MIL-M-28787/41B(SH)
AMENDMENT 2
8 March 1991
SUPERSEDING
AMENDMENT 1
5 March 1984

MODULES, STANDARD ELECTRONIC

FLIP-FLOP, JK, DIGITAL, KEY CODE EBL

FIGURE 23. Power supply transient amplitude test circuit for table XVII.

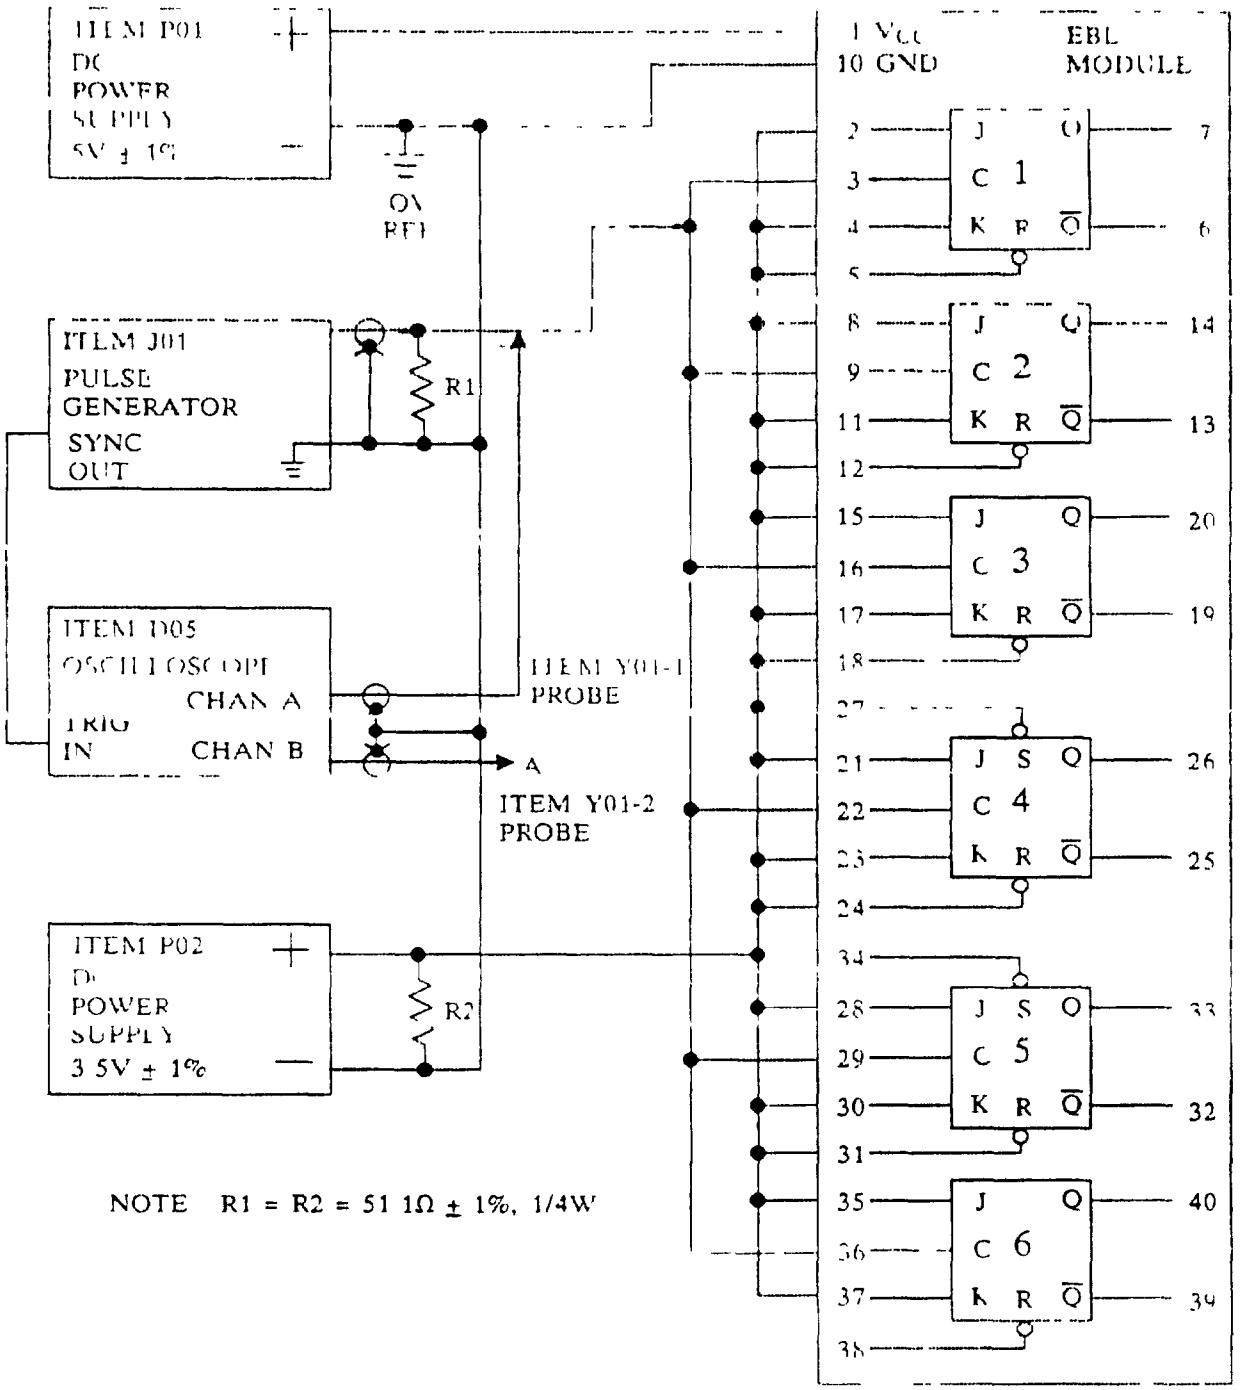
* FIGURE 23. Delete and substitute new figure 23 as printed on page 3 of this amendment.
